JULY 30, 2025

CONTRACT NO. 1800

WET WEATHER PUMP STATION

ADDENDUM NO. 6

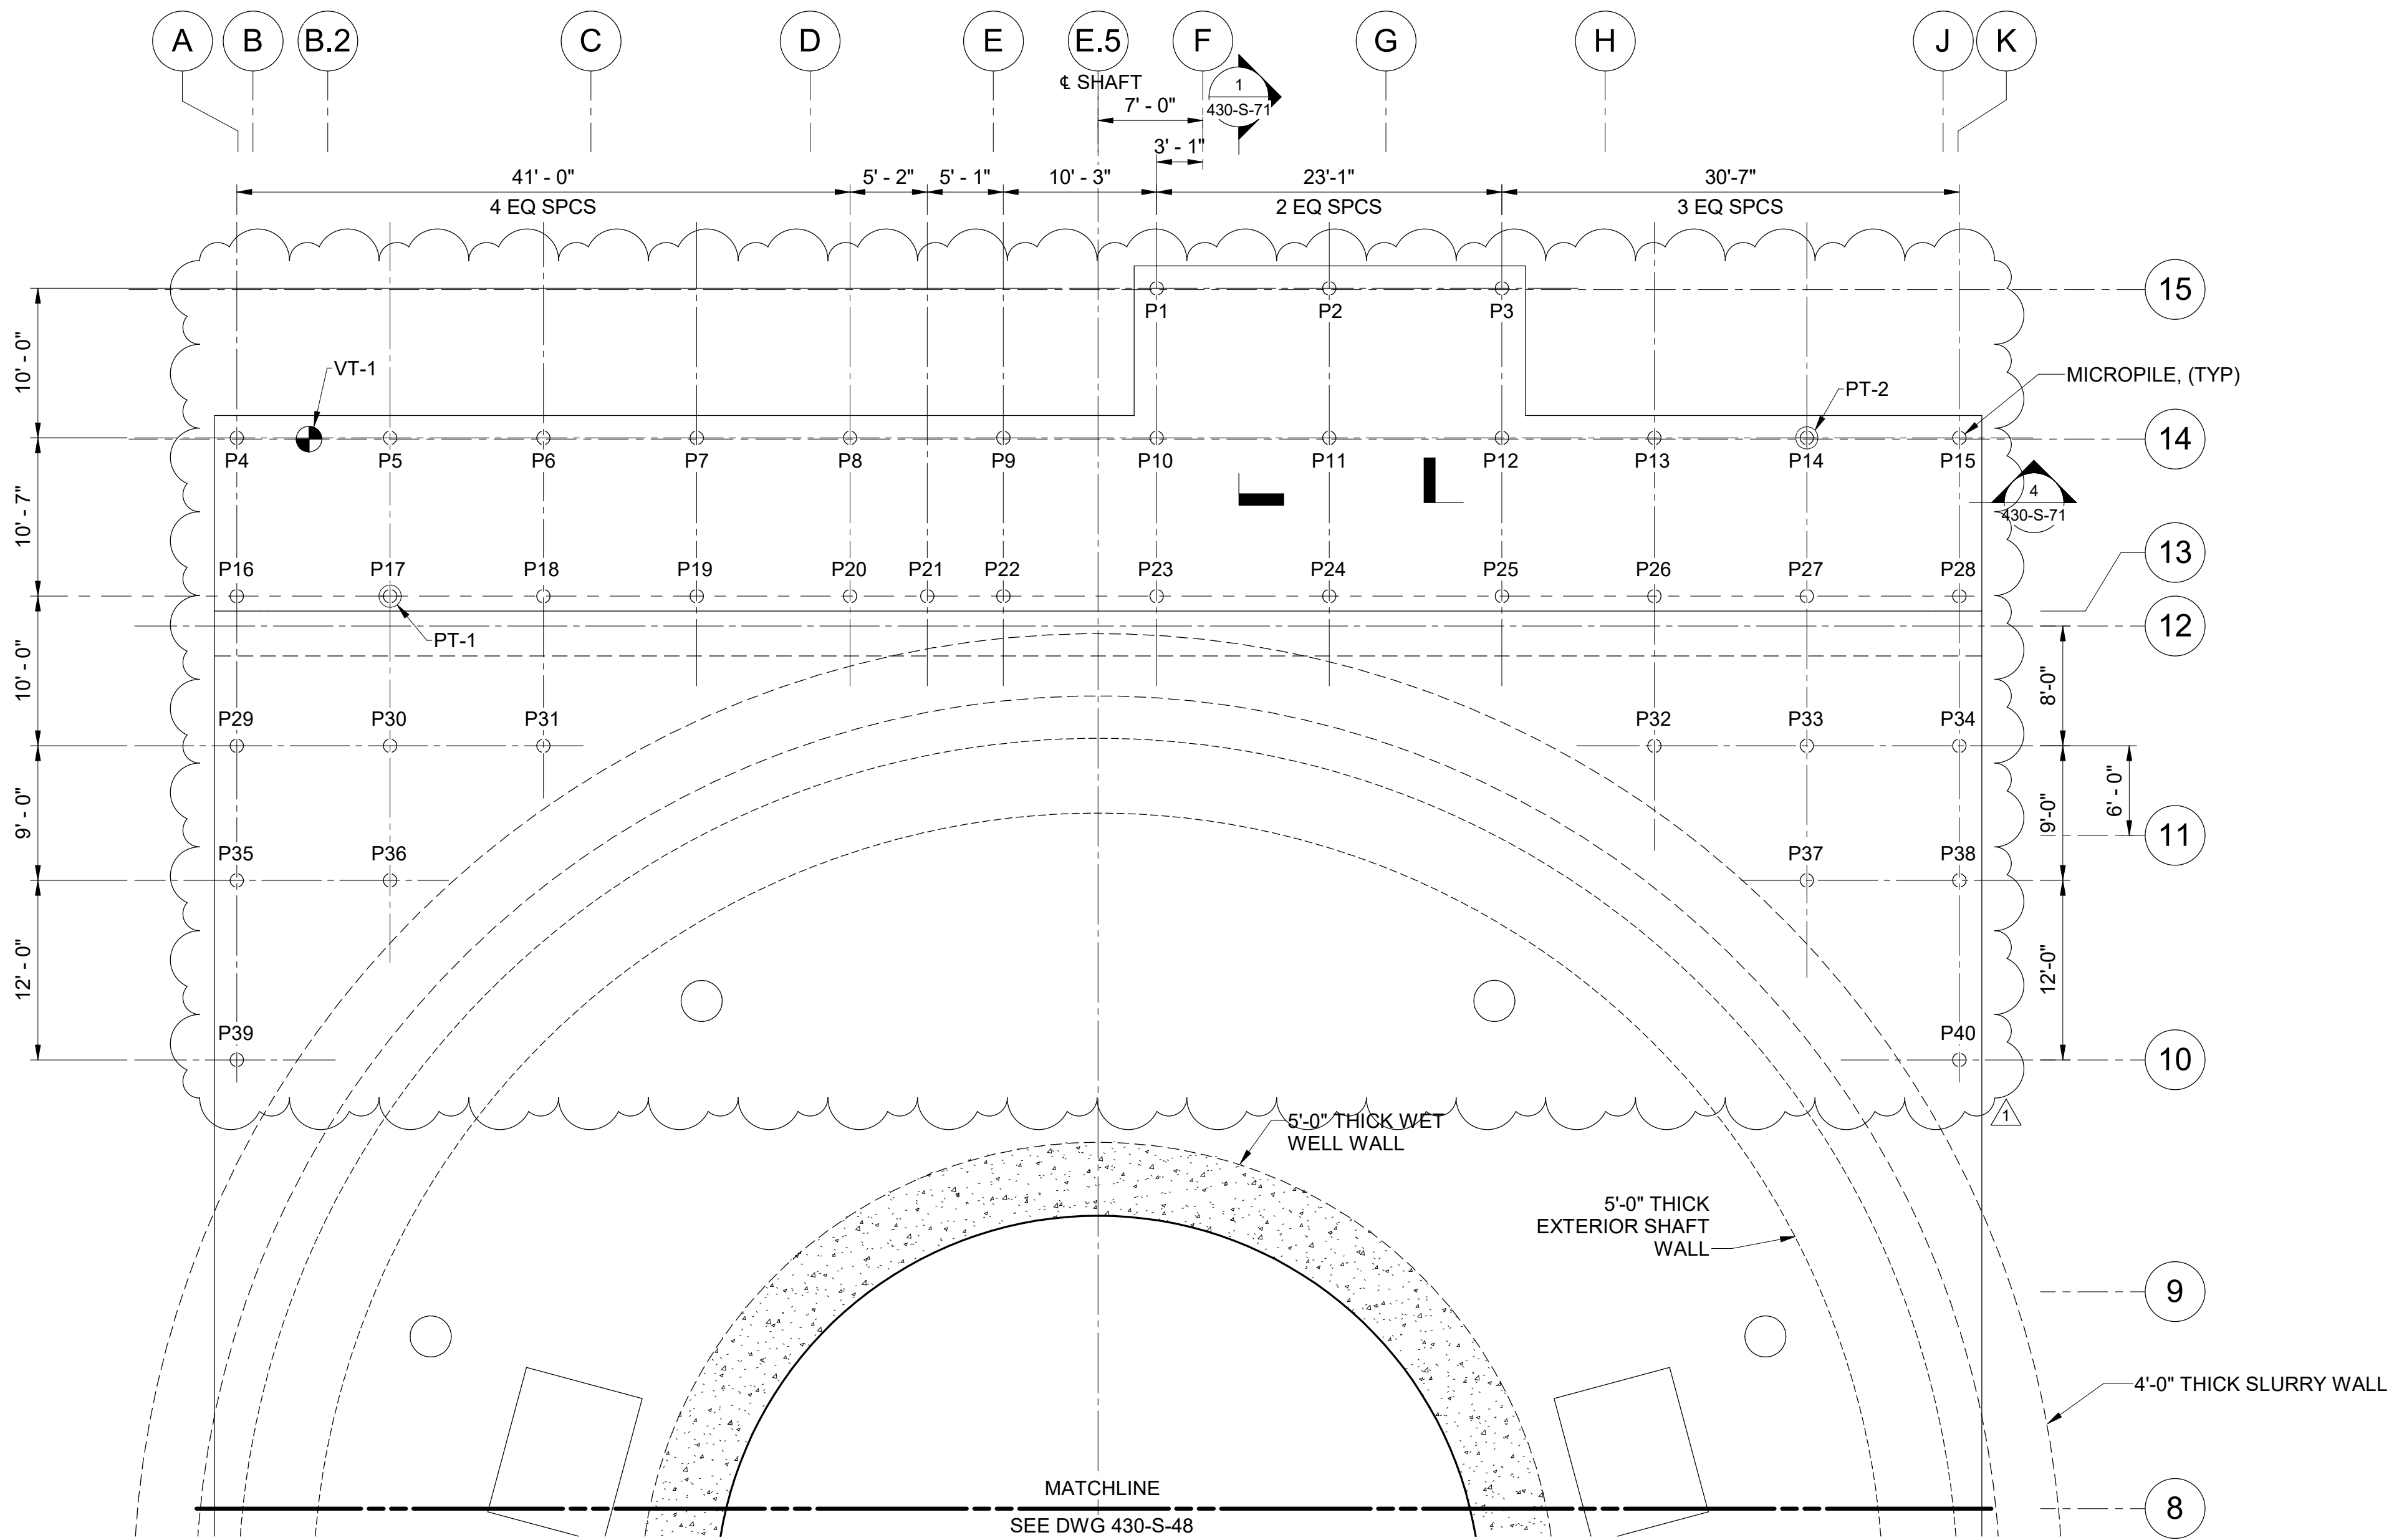
- 4.1 **REPLACE** Sheets 430-S-47 and 430-S-48 with Sheet 430-S-47 Rev. 01 and 430-S-48 Rev. 01, refer to Attachment C.
- 4.2 **REPLACE** Sheets 430-A-09, 430-A-20, 430-A-28, 430-AS-01, and 430-AD-09 with Sheets 430-A-09 Rev. 01, 430-A-20 Rev. 01, 430-A-28 Rev. 01, 430-AS-01 Rev. 01, and 430-AD-09 Rev. 01, refer to Attachment C.

Question - Are the 7 proof load tests to be performed at the locations shown on Drawings 000-C-17, 430-S-47 & 430-S- 48 or selected at random as described in the quoted specification language?

- A55:** Drawings 430-S-47 and 430-S-48 have been revised. Refer to Item 4.1. of
